REV B 10/24/2015
REV A 10/9/2015
DRAFT 3/25/2015

Title	5 POER EXPANDER BOARD
Size D	Document Number <Doc> Rev B
Date: Thursday, October 22, 2015	Sheet 1 of 1

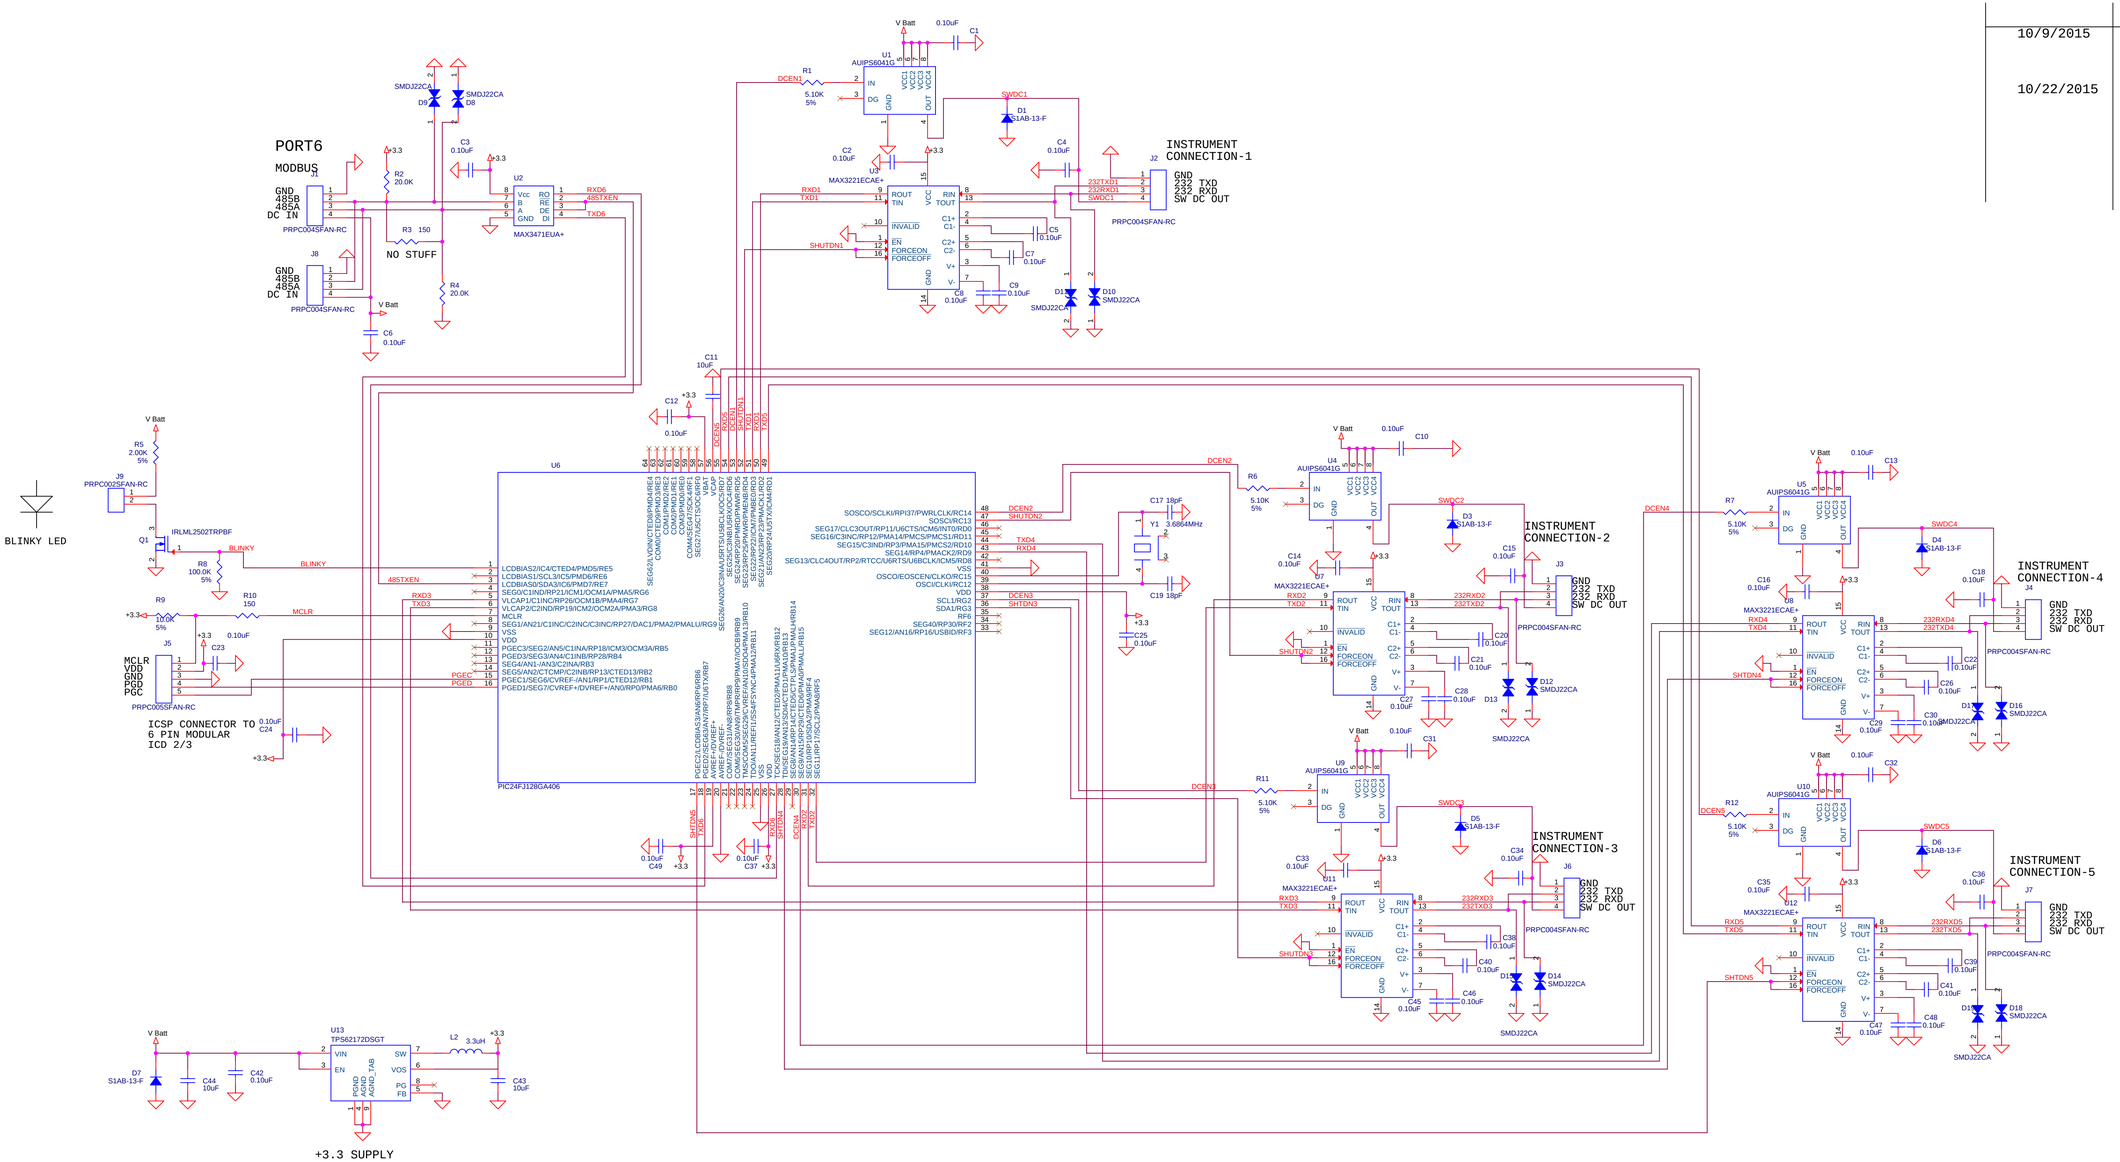
REV HISTORY	
10/9/2015	tie VUSB AND AVDD TO 3.3, add C49 at AVDD change to PIC32MX575F256H-80I/PT REMOVE LED, ADD J9 FOR EXTERNAL LED
10/22/2015	CHANGE TO pic24
